ADDENDUM NO. TWO

24 FEBRUARY 2020

PROJECT TITLE: JACKSONVILLE STATION
1300 NORTH MARINE BOULEVARD/HWY 17 NORTH
JACKSONVILLE, NORTH CAROLINA
JACKSONVILLE PROJECT NO. BP19-00002283
HRA COMMISSION #189518.00

H R ASSOCIATES, P.A. ARCHITECTURE-INTERIOR DESIGN <small>RALEIGH, NORTH CAROLINA</small>					
STAFF MEETING ROOM #106/ I.T. ROOM #114 SIZE CHANGE				PROJECT: JACKSONVILLE STATION COLLOCATION CHANGE NOTICE NO: ACN-A-001 SHEET: 1 of 1	
DRAWN BY: GDG	CHECKED BY: JUF	DATE: 2/24/2020	REVISION: -	DRAWING NUMBER AFFECTED: A2.3, A2.4 & A9.2	
H R ASSOC. JOB NUMBER: 189518.00

TRANSPORTATION/ADMINISTRATION WING - LAYOUT

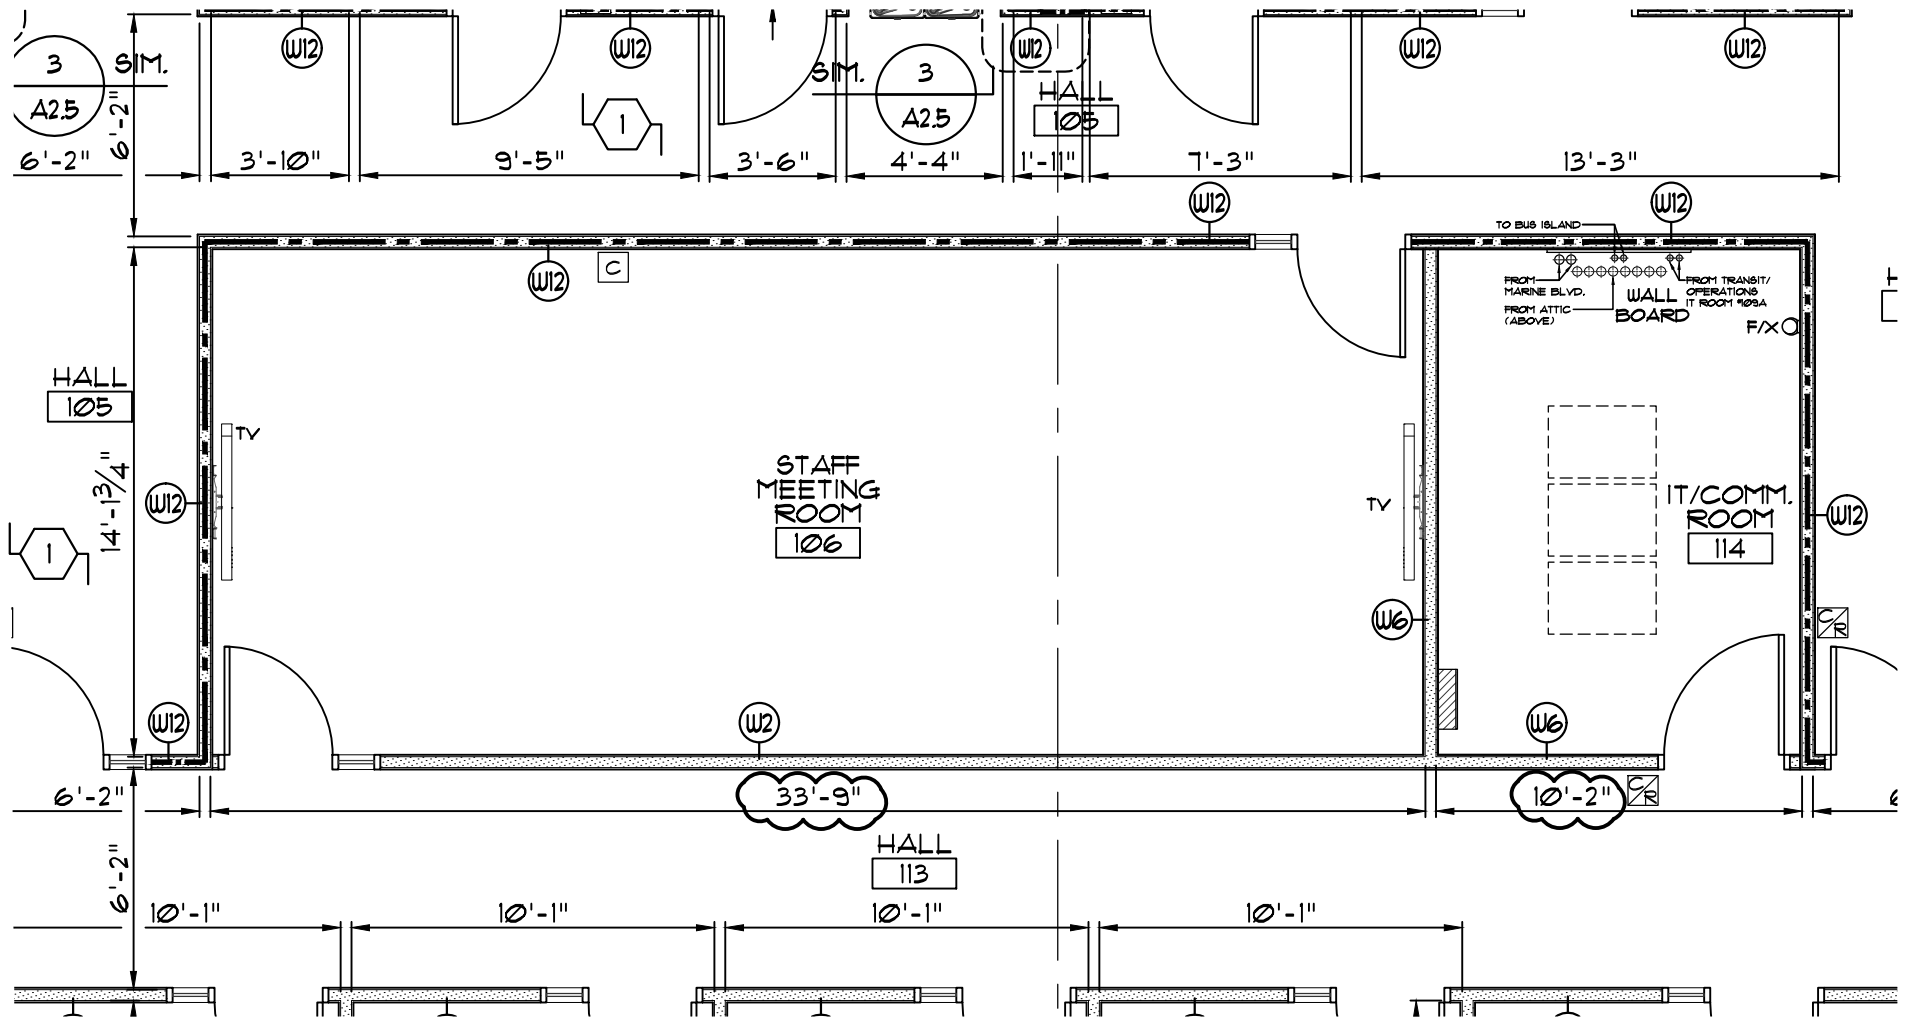
1. Drawing #A2.4_FloorPlan – Transportation/Administration Wing - Layout:
 - a. Staff Meeting Room #106 and I.T. Room #114, overall room sizes have been revised – See attached ACN-A-001; along with associated plumbing, mechanical and electrical listed below.
2. Drawing #A9.2 Door Schedule:
 - a. Transportation/Administration Wing/Door #114 – Delete frame/door assembly 20 Min. rating requirement.

1. Transportation/Administration Wing I.T. Room #114:
 - a. Remove the floor drains required for in-line cooling units. Remove 1/2" cw line originally serving the AH humidifier.

1. Transportation/Administration Wing I.T. Room #114:
 - a. Delete 5-ton Liebert system serving IT/Communications Room #114 including all associated ductwork, diffusers and grilles from the plans. Replace Liebert unit with a ductless ceiling-mounted cassette unit with remote thermostat mounted in IT/Communications Room.

1. Transportation/Administration Wing I.T. Room #114:
 - a. Server equipment quantity reduced and UPS (power supply) has been integrated into the server racks. Panel breaker quantity/sizes to remain the same as scheduled.
2. Coordinate electrical feed and breakers to revised mechanical equipment.
3. Add breakers and conduit out to parking lot (last two (2) parking spaces at southwest corner of the Transportation wing near standby generator). Coordinate and include owner furnished car chargers.
4. Shift receptacles and equipment to match new floor plan in IT room and Staff Meeting room.
